MEMORANDUM

RE: Site Survey for Proposed Wastewater Land Application Sites
Essentia Protein Solutions, NPDES Permit No. 8300100, Work Request No. 4080,
Staff Action No. 122800

The aerial photo below documents the proposed field, labeled as Site 7 (located in the NW ¼, Section 33, Center Township, Shelby County).

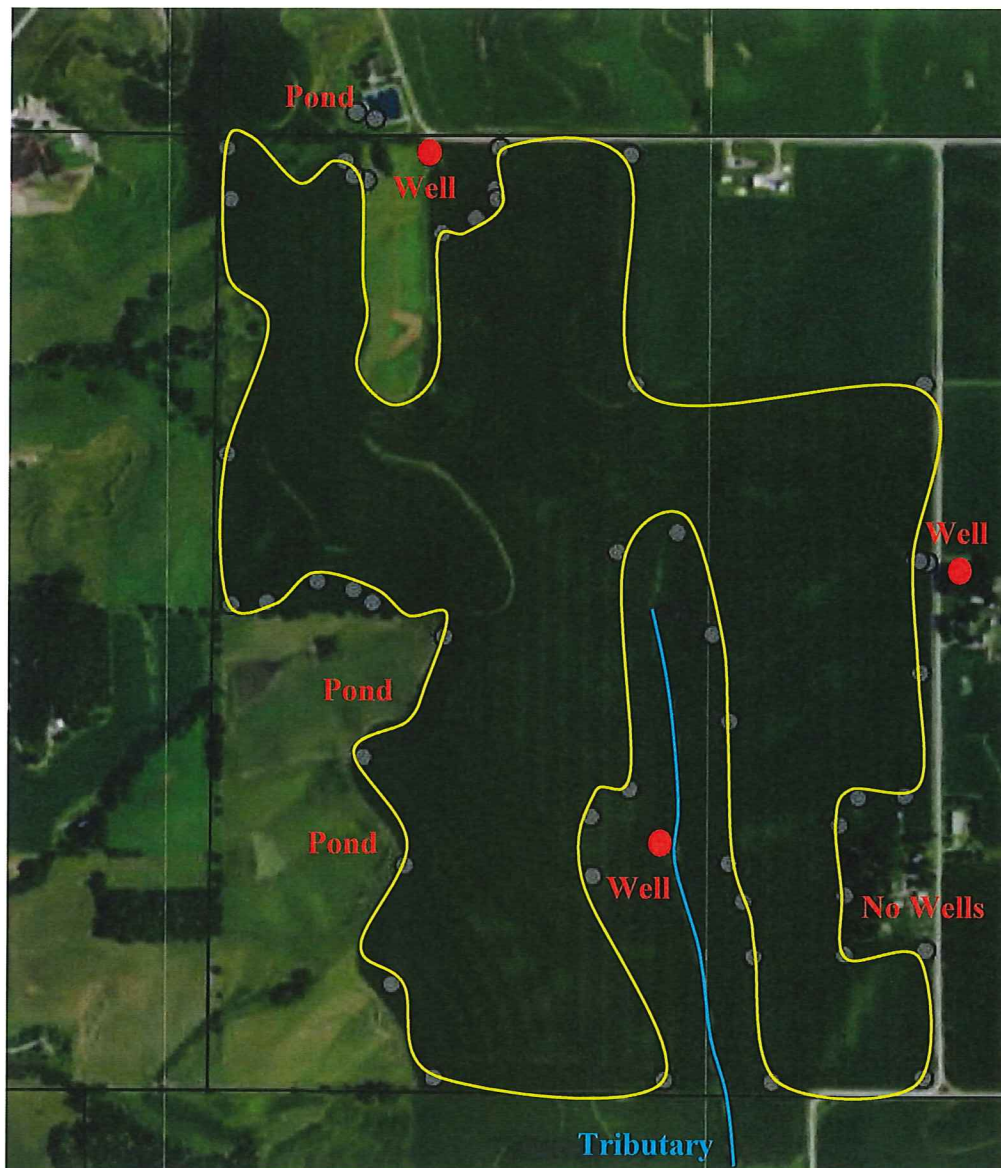
According to the engineering report, this field consists of 111.2 acres, 83.9 acres to be used. However, the engineering report did not account for a well located at 1528 800th Street (northeast well on aerial photo). The field near this well had to be restaked and another survey conducted the next day to verify distances. **Correct acres should be submitted and accurate acres included in the operation permit for this field.**

I verified the location of the unnamed tributary of the East Branch of the West Nishnabotna River and where the tributary begins in the field. The photos below document my observations and the aerial photo above documents the approximate location.

I verified that all separation distances have been met.

The aerial photo below documents the proposed field, labeled as Site 10 (located in the NW ¼ and the SW ¼, Section 32, Center Township, Shelby County)..

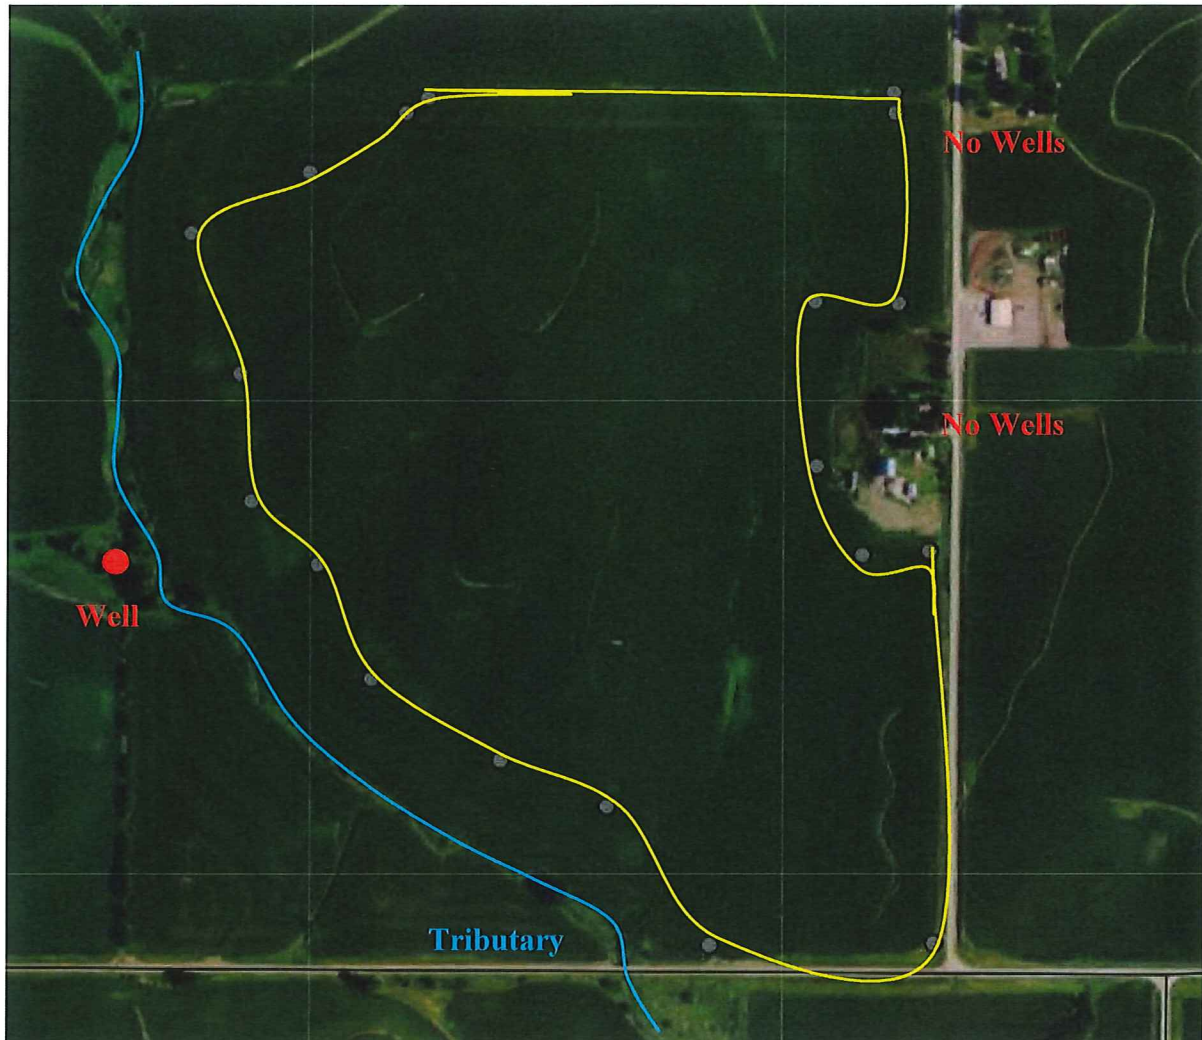
According to the engineering report, this field consists of 366 acres, 297.7 acres to be used. However, the engineering report did not account for three wells, one located on the north side of the field, one located on the west side of a tributary of the East Branch of the West Nishnabotna River, and one located at 723 Oak Road. A couple of the stakes had to be relocated while I was on-site in order to meet the required separation distances; however, Essentia staff obtained new GPS coordinates for these stakes. Additionally, a small portion of the field, located along the north portion is in pasture. **Because the proposed application is injection or incorporation, correct acres should be submitted and accurate acres included in the operation permit for this field.**

I verified that all separation distances can be met.
